**Environmental Assessment of Ground Water Compliance
at the Gunnison, Colorado, UMTRA Project Site**

Final

SUBJECT: NATIONAL PARK SERVICE RESPONSE TO DRAFT ENVIRONMENTAL
ASSESSMENT OF GROUND WATER COMPLIANCE AT THE GUNNISON, COLORADO,
UMTRA PROJECT SITE WORK PLAN AND GUNNISON PUBLIC MEETING

**Response to Comments from the National Park Service (NPS)
on the Gunnison, Colorado, UMTRA Project Site
in a Letter to DOE Dated April 10, 2002**

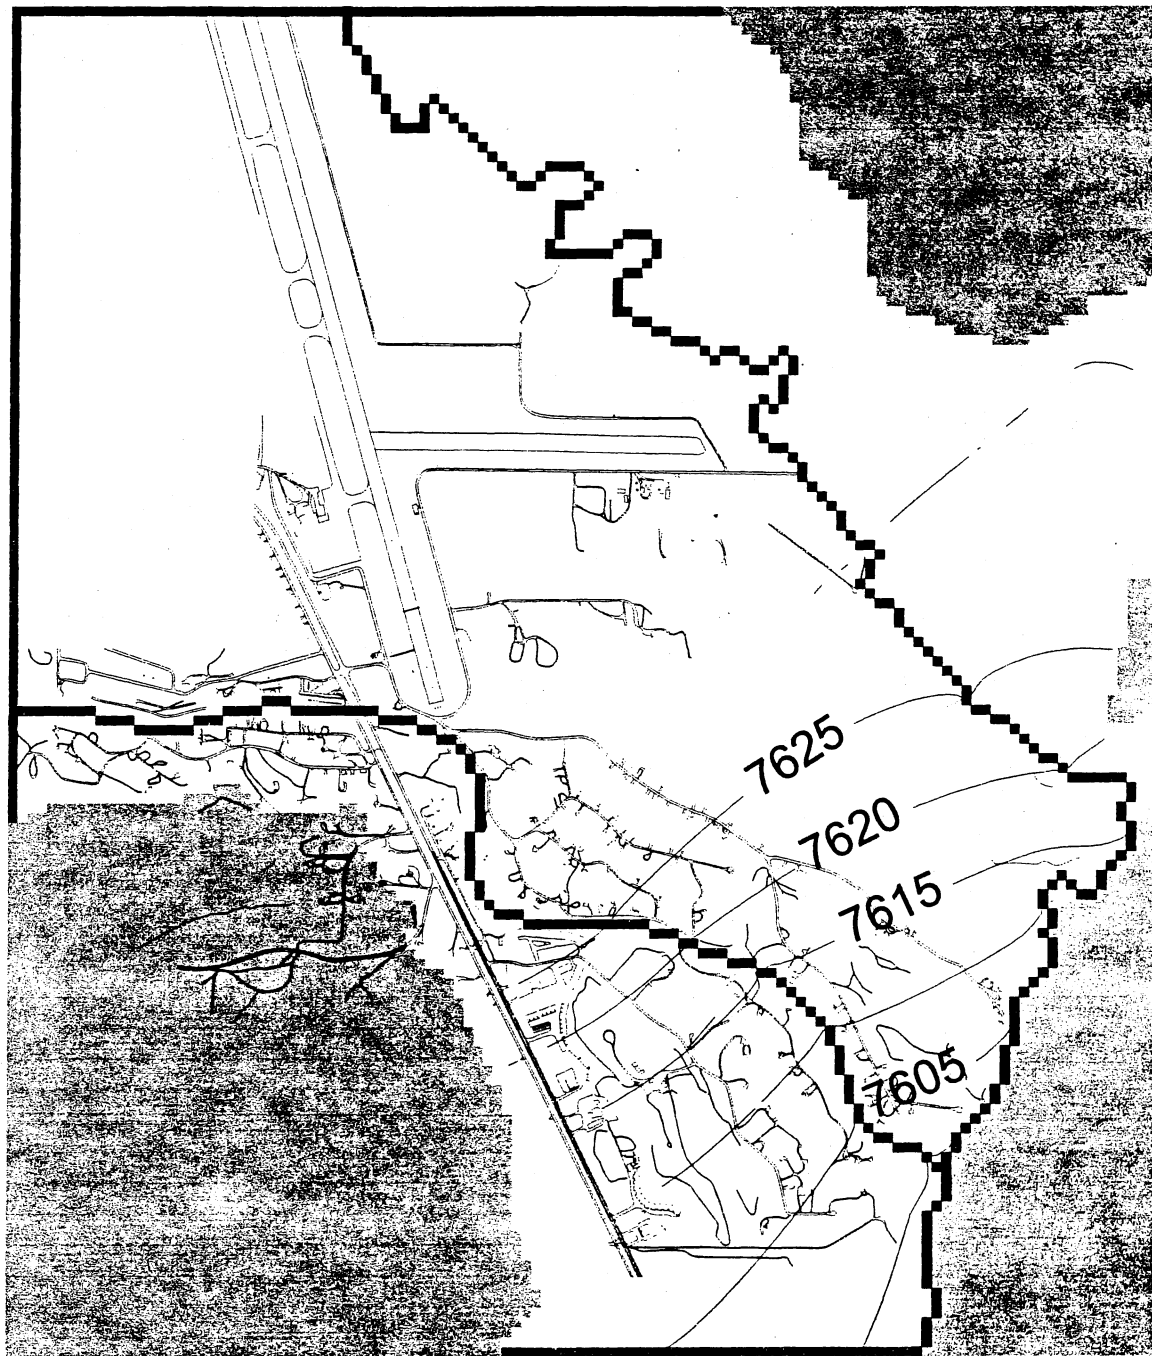
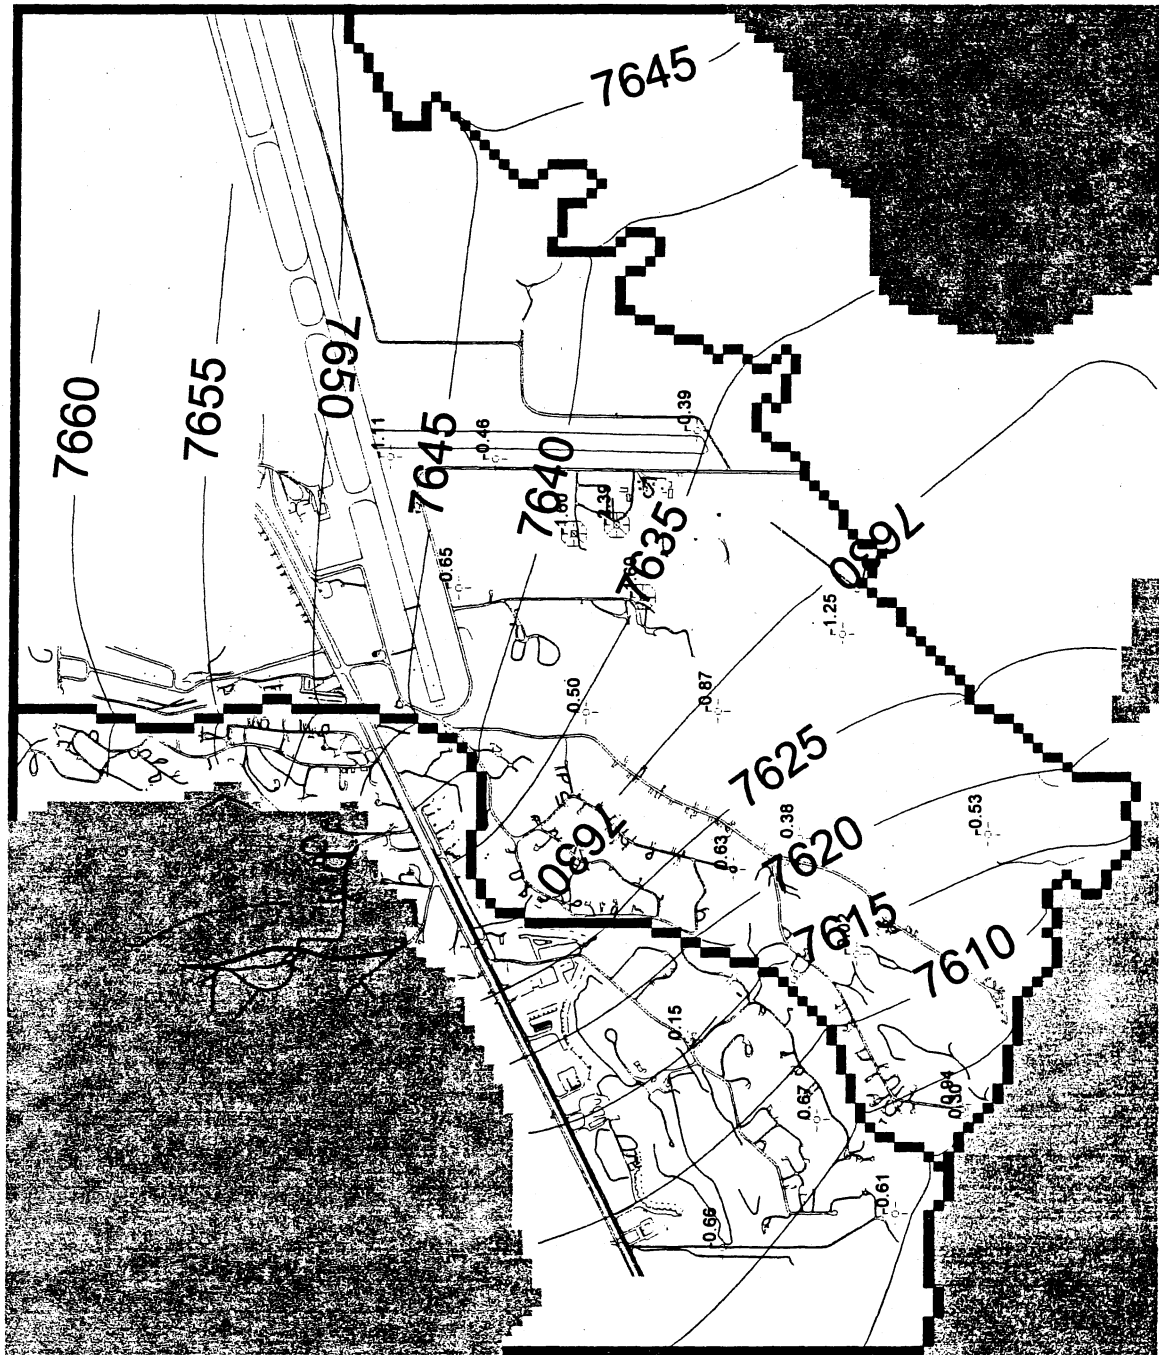
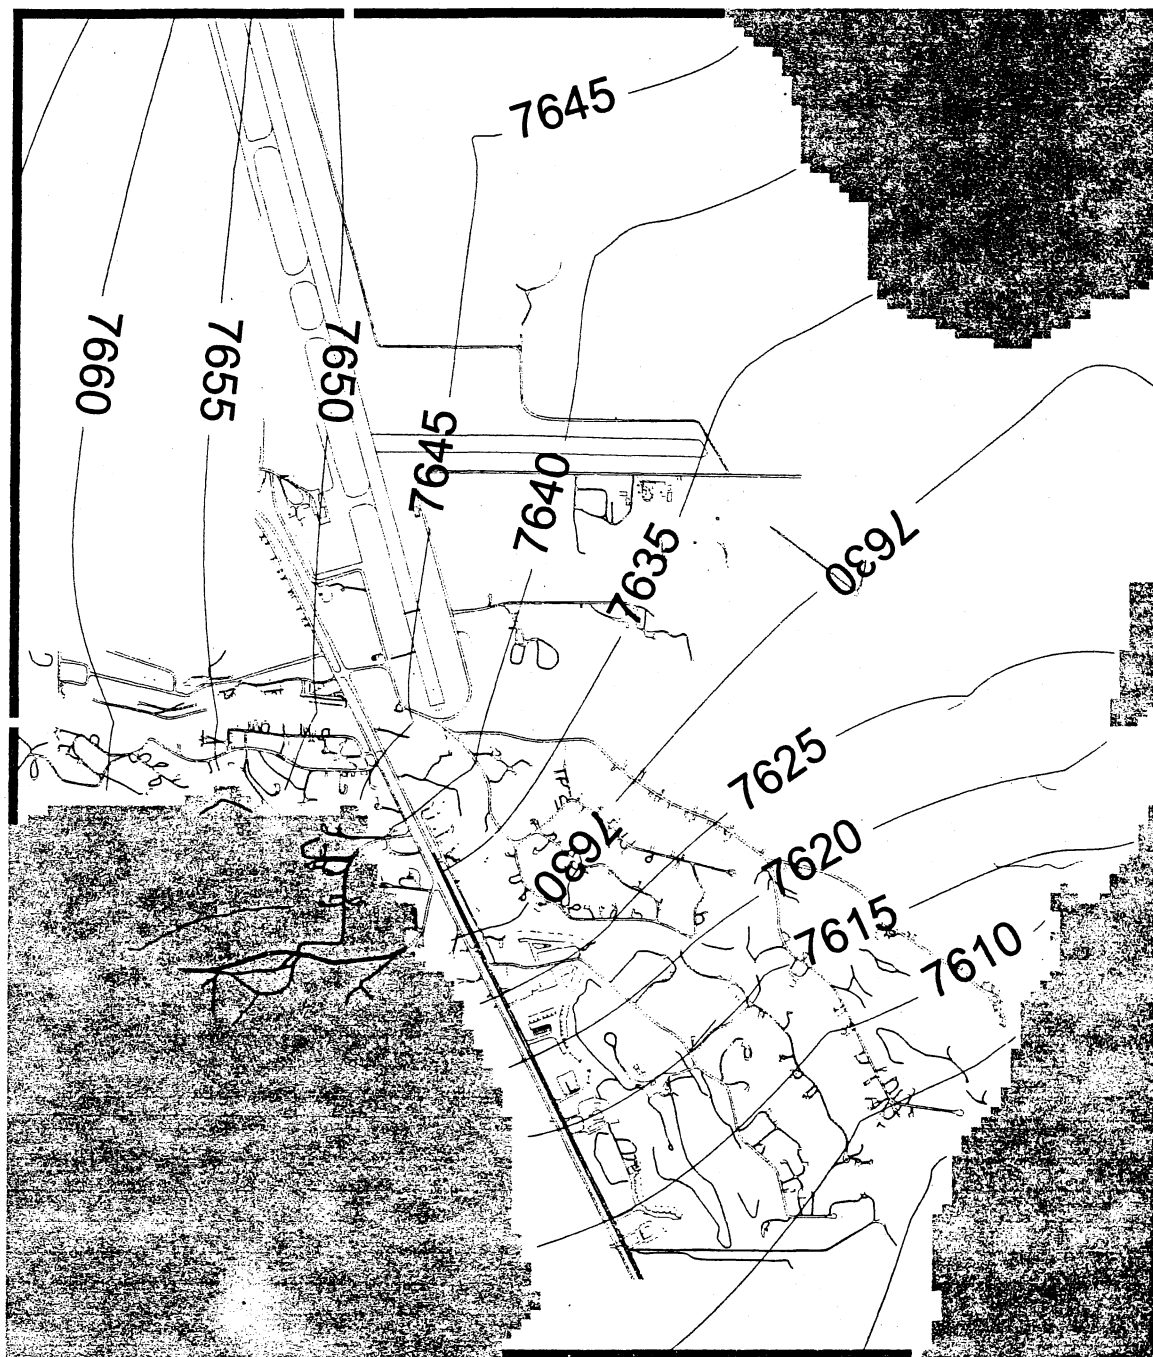
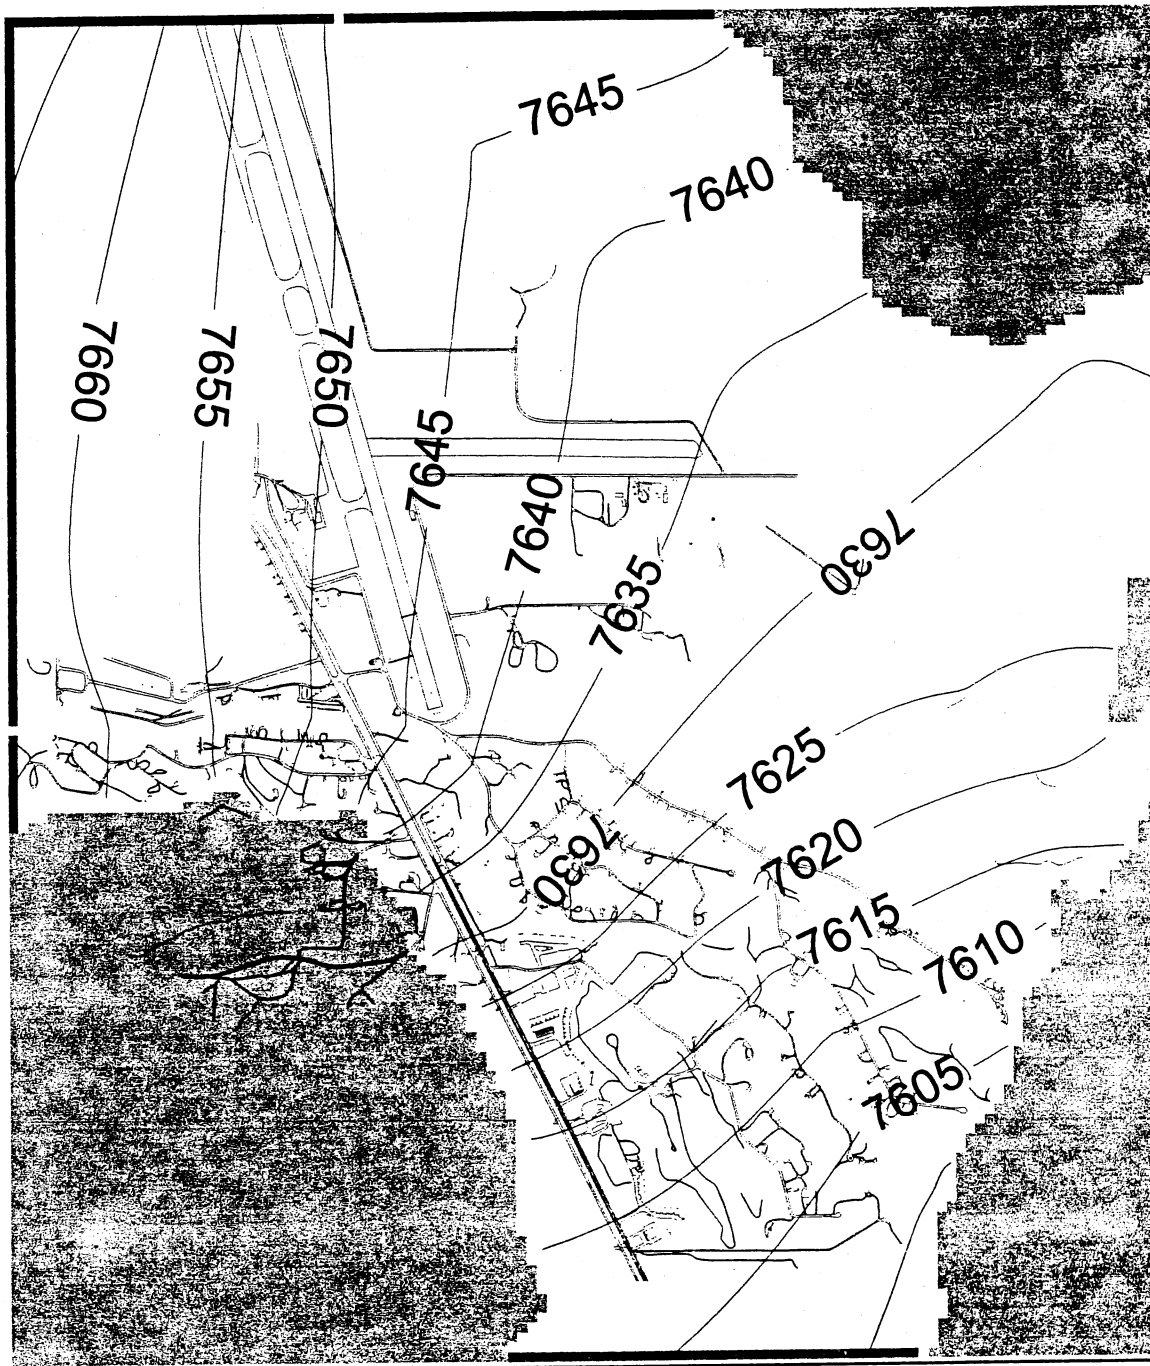
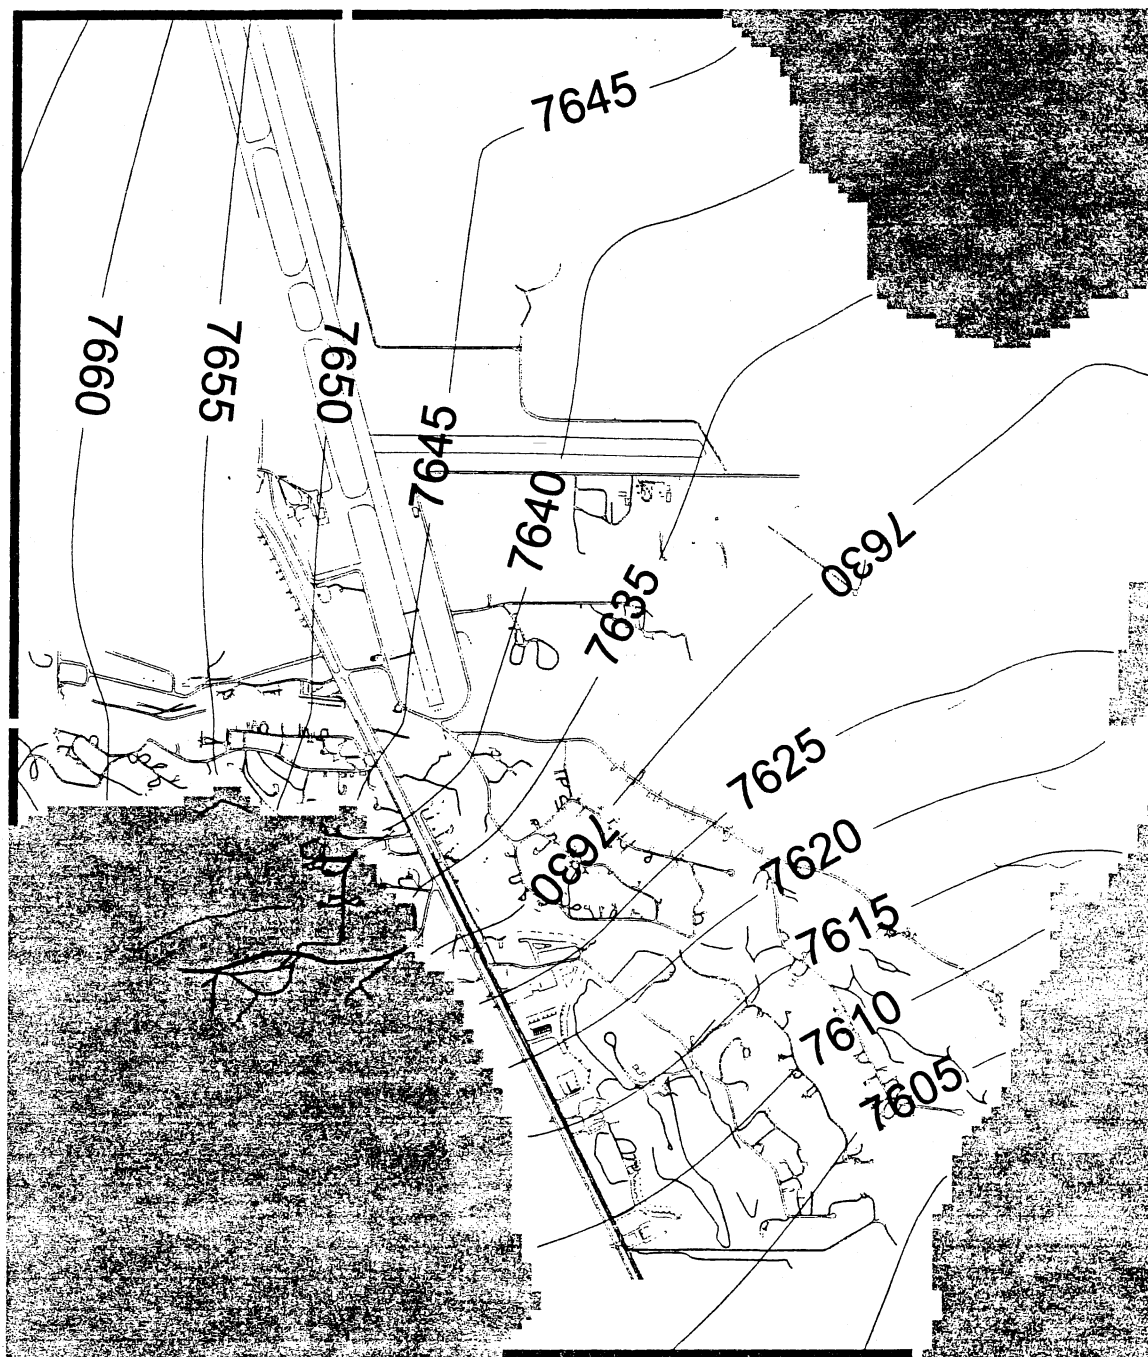
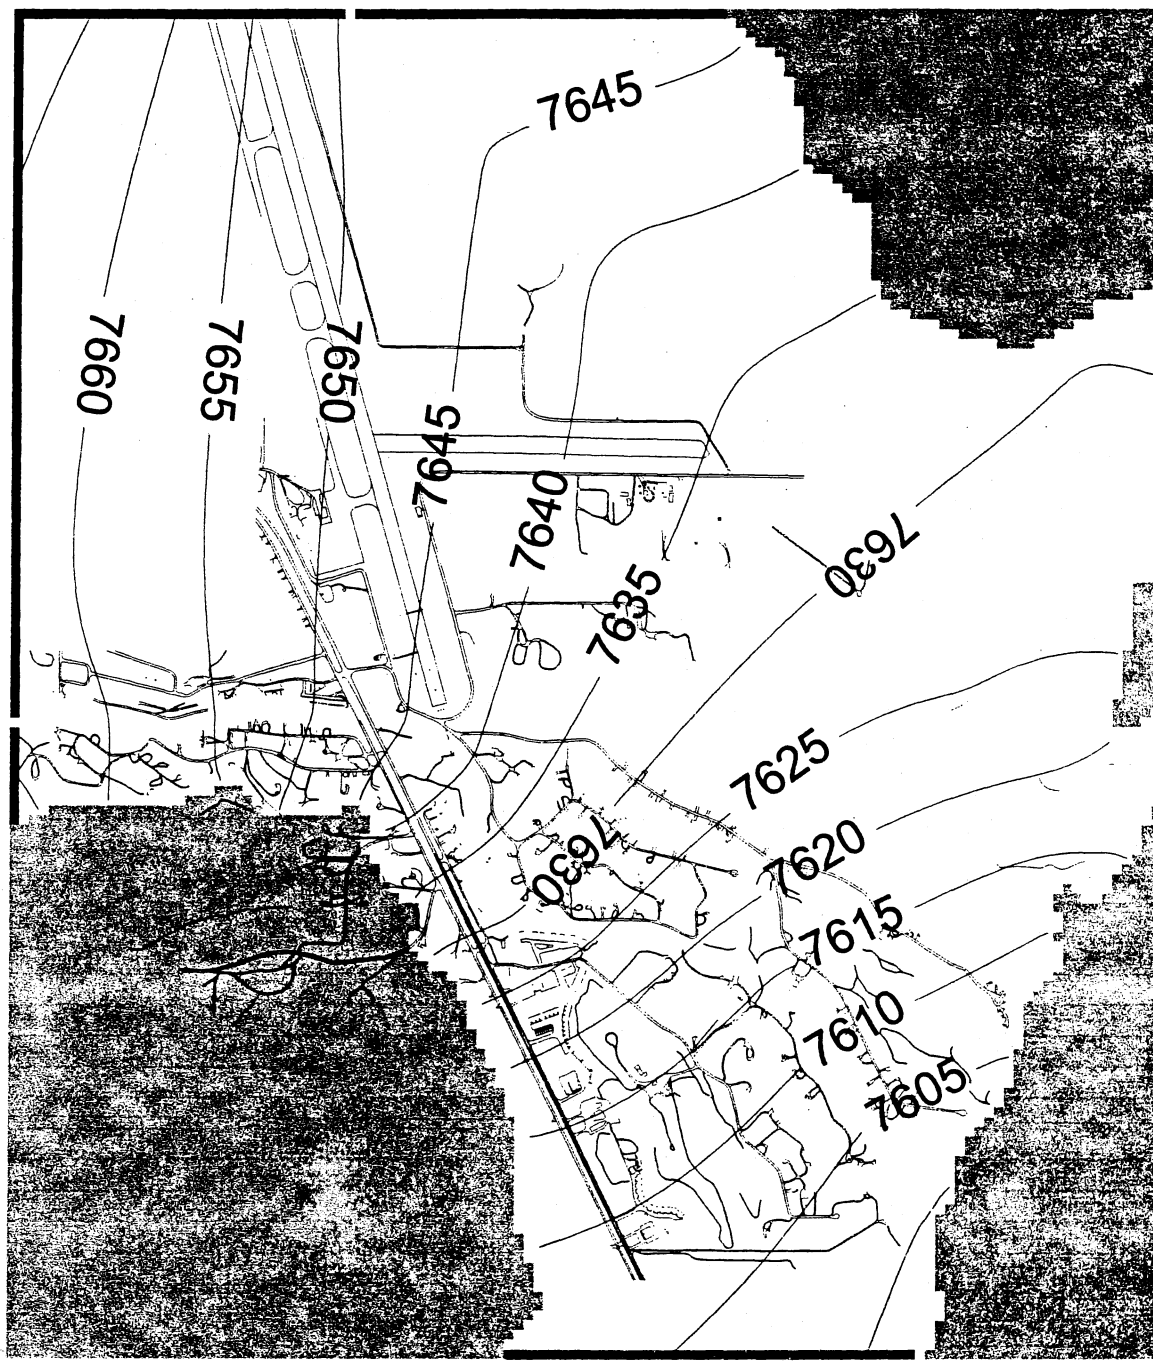
- 1) Flow Modeling: The *Work Plan* presents field and modeled water level for only the intermediate zone. Please show field and modeled water levels for the shallow zone, and for layer 3. In addition, please show or discuss the values used for the starting heads in the shallow aquifer.

Response: The initial water level (starting heads) used for all seven layers was 7620 feet. This is an average value in the middle of the site. The model was run with these as starting heads to get a final head solution. The final head solution for simulation #1 then becomes the initial head for simulation #2. This substitution of final head from simulation n for initial head for simulation $n+1$ continues until the simulation converges within a few iterations (less than 10) and the simulated drawdown is essentially zero everywhere. Plots of simulated water level are attached for all seven layers.
